UNITED STATES PATENT AND TRADEMARK OFFICE

APPLICATION NO.	FILING DATE	FIRST NAMED INVENTOR	ATTORNEY DOCKET NO.	CONFIRMATION NO.
10/820,877	04/09/2004	Satoshi Fujioka	Q81013	9270
23373	7590	08/19/2005	EXAMINER	
SUGHRUE MION, PLLC 2100 PENNSYLVANIA AVENUE, N.W. SUITE 800 WASHINGTON, DC 20037			COLILLA, DANIEL JAMES	
			ART UNIT	PAPER NUMBER
			2854

Office Action Summary

DETAILED ACTION

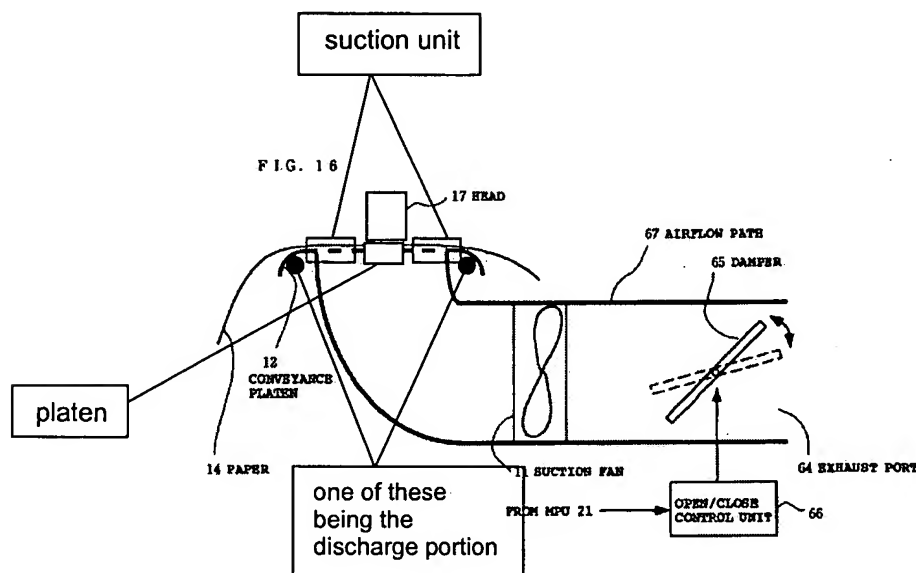
With respect to claim 6, Fukuda discloses a recording apparatus including a suction unit positioned between a platen (in this interpretation the platen is the media support surface directly opposite the recording head 17) and a discharge portion as shown below in the Figure taken from Figure 16 of Fukuda:

The platen is opposite a recording head 17 as shown above. It is not known to the examiner which end of the device is the discharge portion, but it inherently must be one of the two areas a shown above. Fukuda further discloses a changing unit 65,66 for changing a sucking force of the
